**BUSINESS OF THE CITY COUNCIL
AGENDA STATEMENT**

ITEM TITLE: Information from Waters Edge on estimated costs associated with the swimming pool.

Norwalk Aquatic Center Evaluation Report
Norwalk, Iowa

March 24, 2016

Plunge Pool Heater Flue

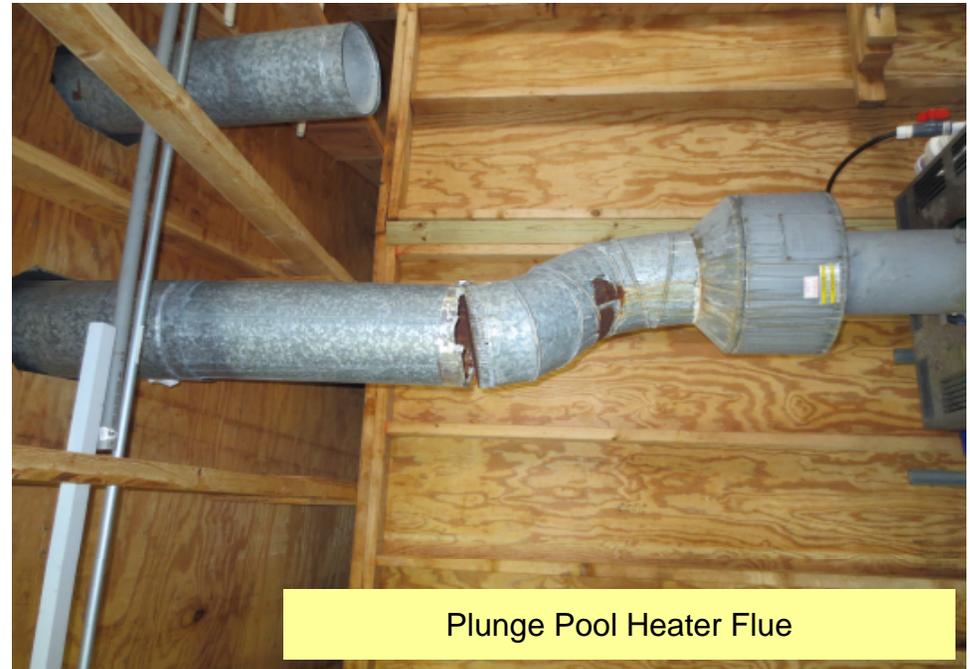
- The existing plunge pool heater flue has come apart and should be fixed prior to operation.
- \$1K**

Pool Equipment Electrical Panels and Fan

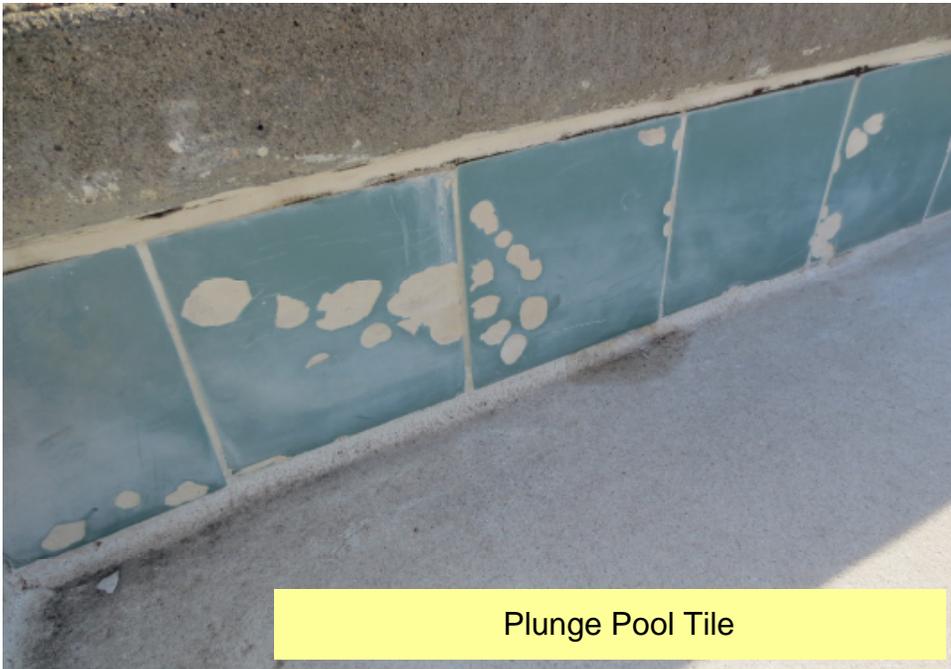
- \$1K** • A fan has been set up to circulate air across the motor starter panels in order to keep the electrical systems operating. An electrician should check to see if the thermal overload protection settings of the panels can be adjusted to allow operation at a higher temperature. If not, the fan will still be needed to cool the panels for the coming swim season.

Abandoned Baby Pool

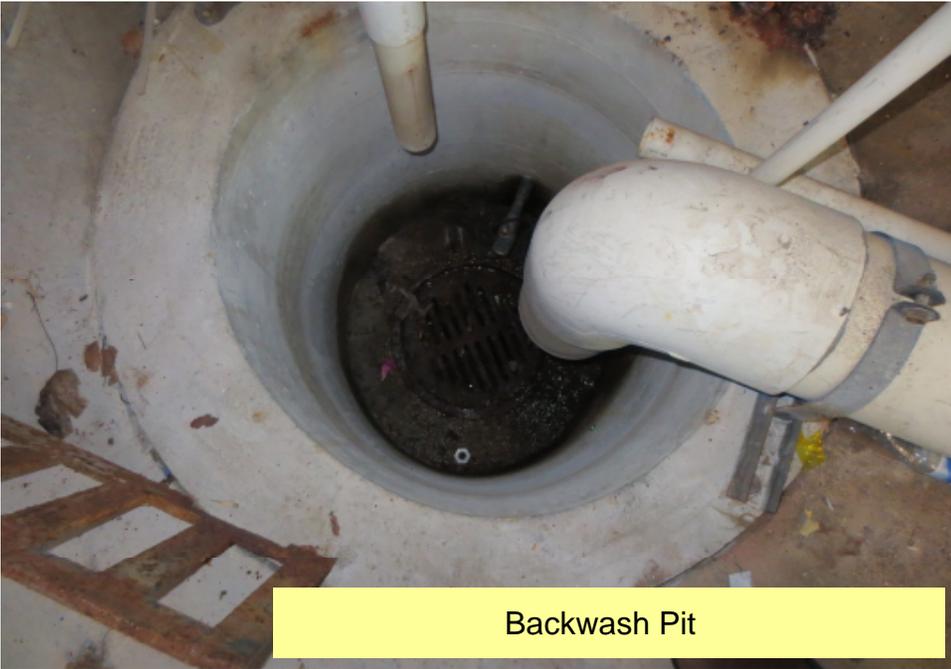
- \$0K** • The baby pool has been closed to the public and has significant offsets at the surface of the pool/deck that are trip hazards. Obviously, vertical movement of the slabs at these joint has occurred, likely due to settlement of the subgrade. Gutter grating has been broken and is hazardous. The pool has two spray features that physically appear to be safe for operation. It is recommended to continue to deny patrons access to this baby pool for the 2016 swim season.

Broken Conduit

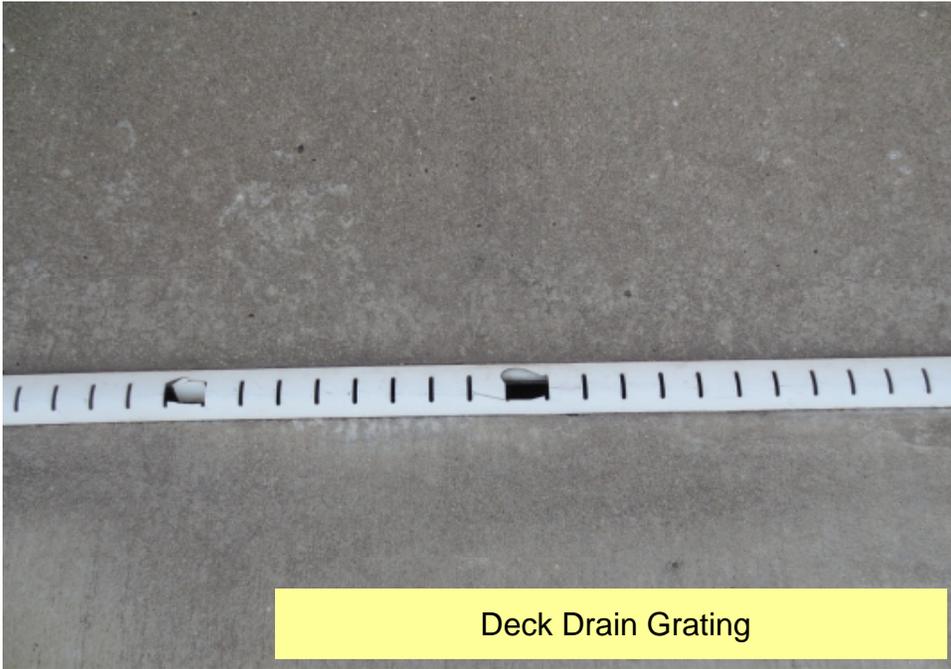
- \$1K** • One of the PVC conduits to an electrical box above the deck along the perimeter fence is broken, exposing the wiring within. This conduit should be repaired before allowing patrons near it.

Fence Fabric Open-Selvage and Gap

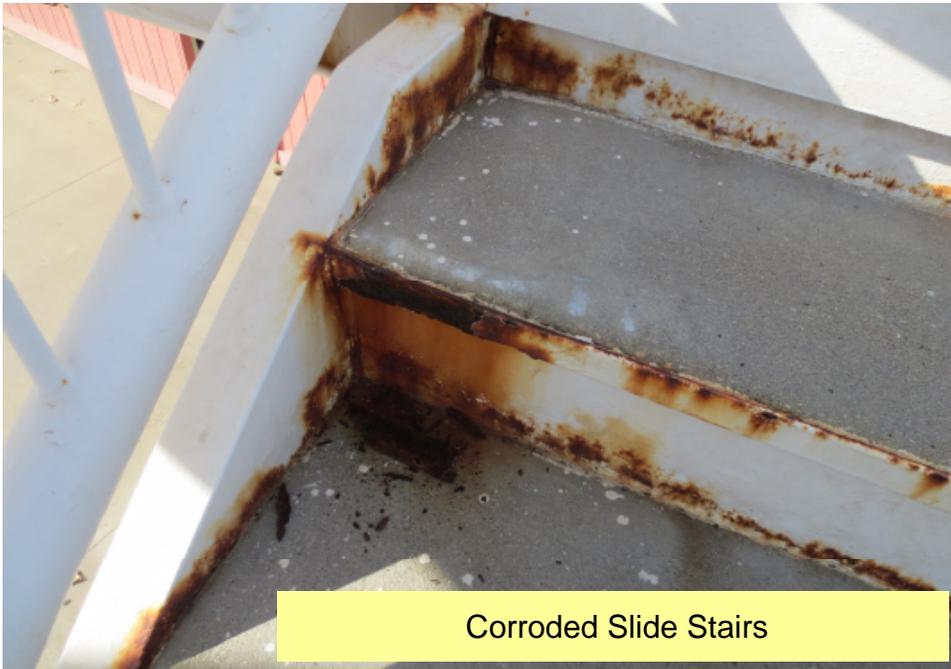
- \$3K** • Much of the chainlink fence within and around the perimeter of the facility has open selvage at the bottom and there's a notable gap between from the fence fabric to the deck surface. This could allow punctures to feet that get under the fence fabric. The fence fabric should be lowered to reduce and/or eliminate the gap prior to allowing patrons in the facility.
- \$8K** • The metallic edge on some of the waterslide step treads has corroded to the point that it has sharp edges. Removal of the corroded metals, rounding off any sharp

edges, and applying a protective coating should be performed prior to allowing patrons to use the slide.

Main Pool Depth Marking

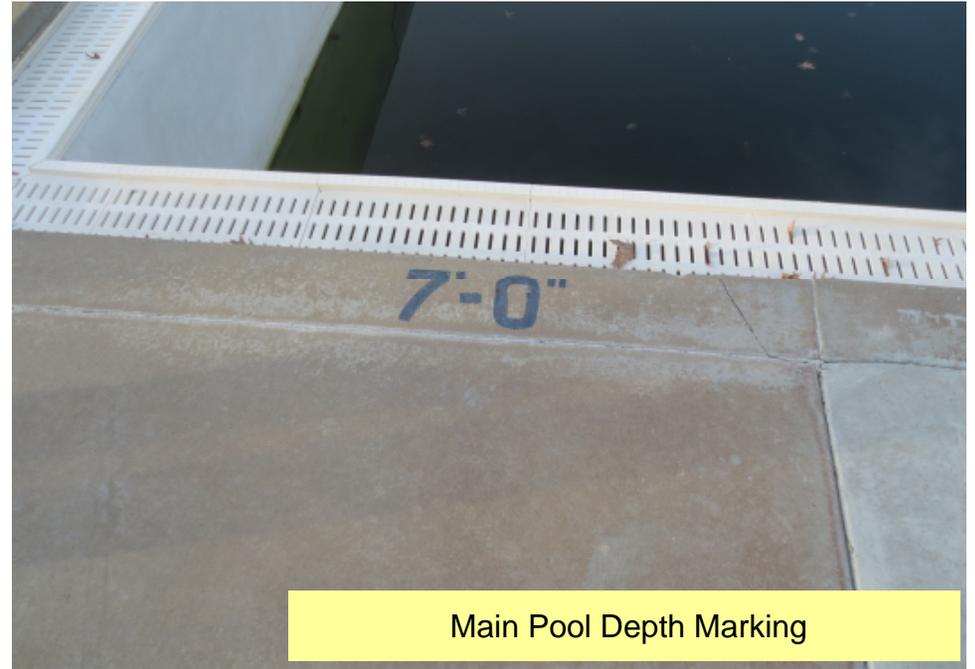
- \$2K** • Additional painted-on depth/warning markings should be added around the perimeter of the pool in order to meet requirement of the IDPH. Depth markings shall be spaced at no more than 20 feet, "no diving" markings shall be at no more than 25 feet, and "max. depth" marking should be added.

Main Pool Caulk Joint

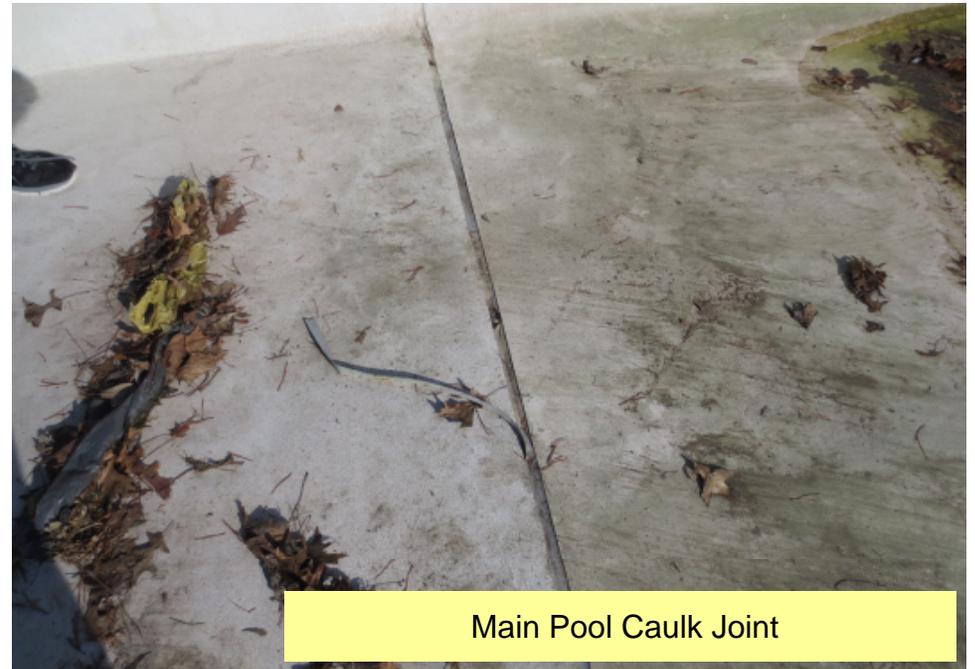
- \$1K** • One of the pool caulk joints has been compromised and should be re-caulked to reduce the potential for pool leakage during the upcoming season.

Main Pool Gutter Grating

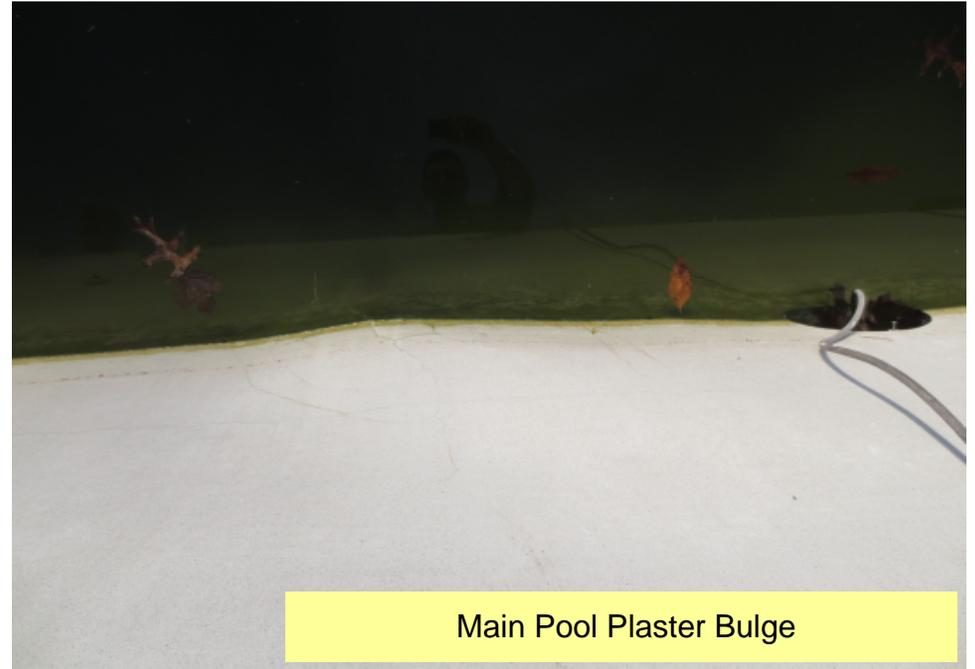
- \$2K** • The structural integrity of the pool gutter grating has been compromised in some areas and needs to be replaced prior to the next swim season.

Manual and Auto-Fill Valves

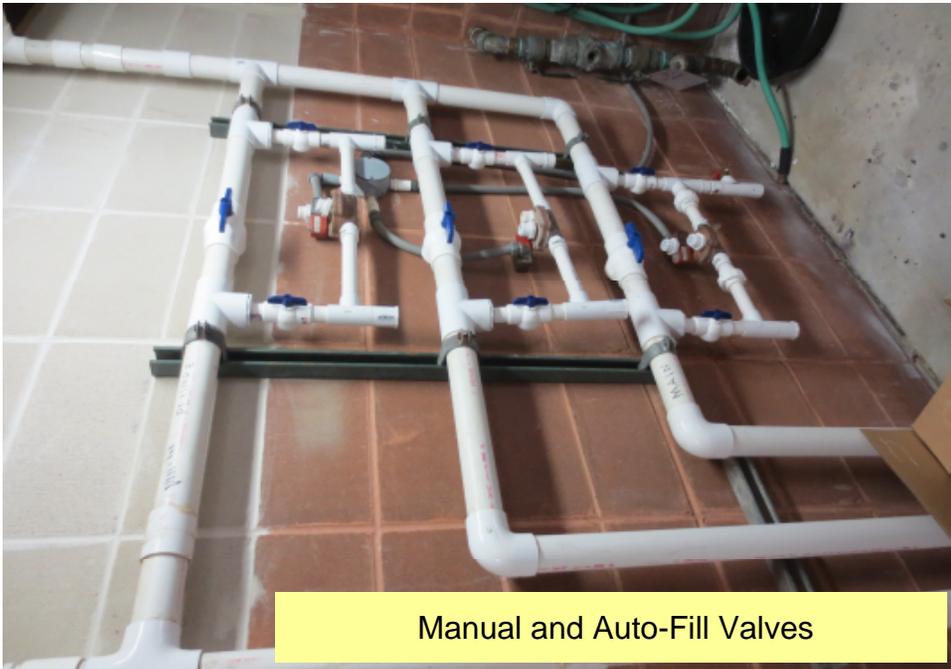
- Potable water is added to the pools by operating existing valves located in the chemical room. One of these manual PVC valves and one of the automatic water feed systems is not functioning properly and should be replaced prior to the start of the next season.
- \$1K**
